## St Kilda Marina Landlord Approval

Council Report 6 October 22

Revised Changes to Lease Approved Concept Design – Updated Proposals for Council Consideration

## Proposal for Additional Retail – Revised

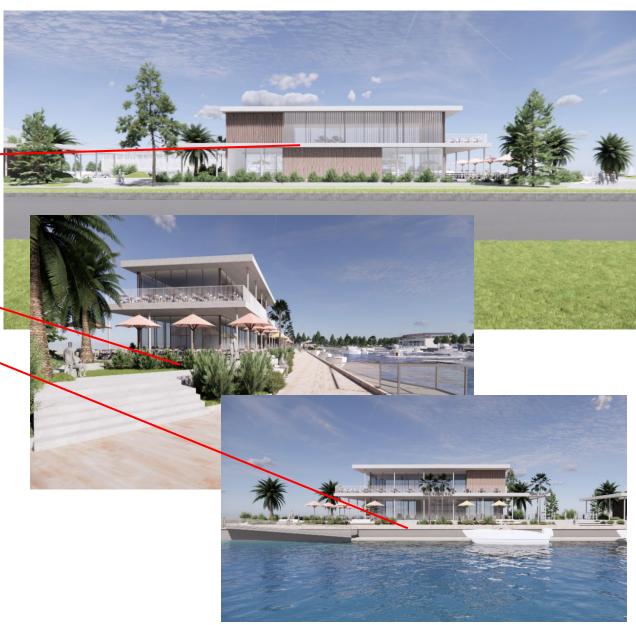
Revised Proposal – 6 Oct (31 Aug Plans) – New (Reduced)

Foreshore Building to accommodate increased NLA

·	Current Design Proposal	Previous Design Proposal	Lease Approved Concept	Recommendation
Proposed Foreshore Building and 2 <sup>nd</sup> Storey to North Building of Marine Parade Retail	Smaller building on carpark located further away from the foreshore than previous iteration. Overall NLA of approx. 1080m2 and footprint of 540m2. Improved design quality.  Addition of a second storey to only the North Building of Marine Pde of approx. 290m2 NLA.	Additional building on the public carpark close to the foreshore. Overall NLA of approx. 1350 m2 and footprint of 675m2.  Single storey retail on Marine Pde	No building on the carpark adjacent the foreshore  Single storey retail on Marine Pde	Conditional approval - the statutory planning process is to confirm that the NLA meets the max. permissible by the planning scheme (5000m2), with any discrepancy to be address through the NLA for the development to replace the service station in 10 years' time. Due to the impact on the public carparking, this is also conditional upon a resolution to the carparking confirmed during the planning process by a traffic and parking report, and a vegetation assessment addressing any impacts at the Moran Reserve interface.

## Floating Venue – Previous Proposal

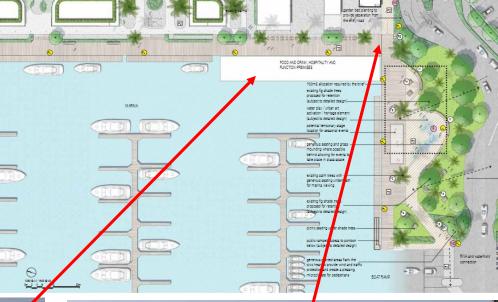
Design Iteration (20 July 22)

## Floating Venue – Revised Proposal

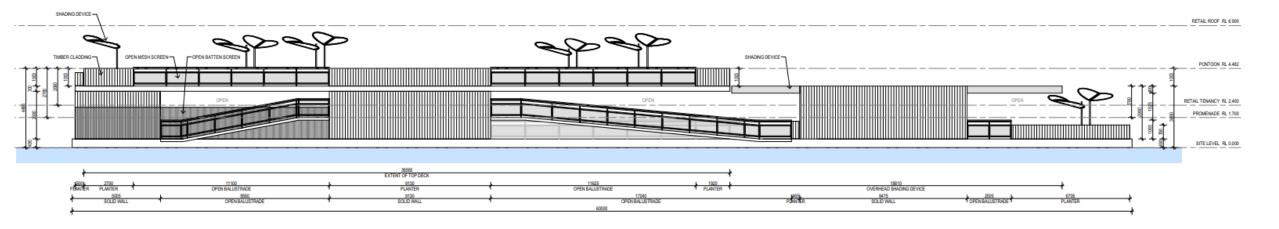
Design Iteration 6 Oct (31 Aug Plans)

Design Iteration 6 Oct (31 Aug Plans) – Elevation from Marine Parade

Promenade & promenade in promen	The proposal is for a 3.5m wide 'slow road' (for vehicles and cyclists) plus passing bays and a 3m wide pedestrian footpath, separated by landscaping elements. This turning circle has less paving. A pedestrian and cyclist path then continues to the tip of the peninsula.	7.6m wide paved peninsula promenade (4m shared pedestrian/bike path adjoining 3.6m vehicle road plus additional width for passing bays).  Large turning circle	Pedestrian/bike path followed the coastline, the vehicle path aligned with building and was separated by a landscape zone.  No turning circle	Conditional approval – AMDC to confirm approval from FRV prior to the conclusion of the planning stage.
d d	The structure is limited to one (enclosed) storey, but with a rooftop deck to allow for outdoor seating and umbrellas. Shifted north to a less conspicuous location.	Two level floating venue in the harbour adjacent Marine Pde retail	No floating venue	Conditional approval - compliance with the planning scheme to be assessed when a submission is made. If not compliant, it will not feature on the site. Any alternative proposal by AMDC for the venue following this assessment is to be resubmitted for landlord approval.

## Peninsula Promenade – Previous Proposal

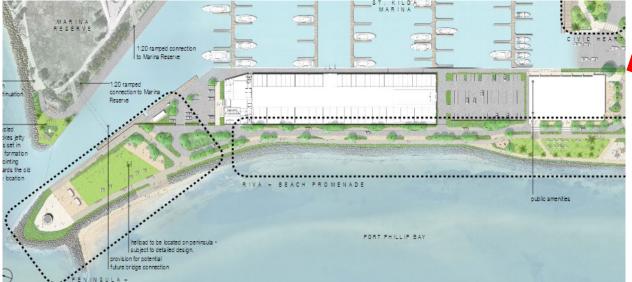
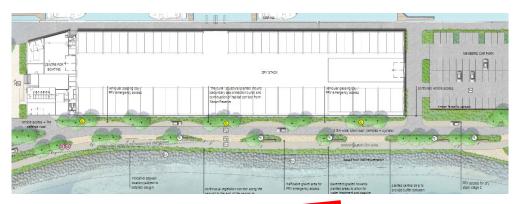
**Lease Approved Concept** – vehicle lane adjacent building separated from pedestrian and cyclist path

**Design Iteration (20 July)** – vehicle lane adjoining pedestrian and cycle path. Vehicle turning circle added

## Peninsula Promenade – Revised Proposal

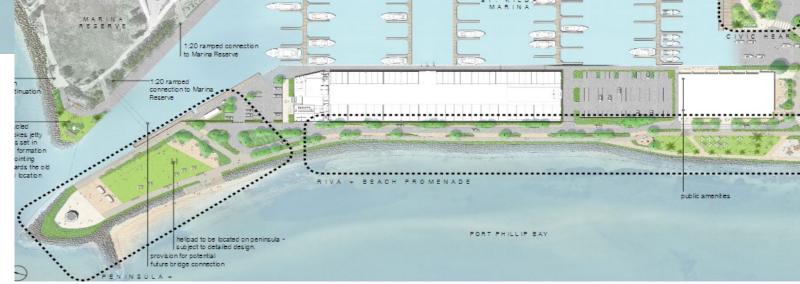
**Design Iteration (20 July)** – vehicle lane adjoining pedestrian and cycle path. Vehicle turning circle added

Design Iteration (6 Oct – 31 Aug Plans) – vehicle lane adjoining pedestrian and cycle path with separated sections through landscaped interventions. Reduced paving to vehicle turning circle.
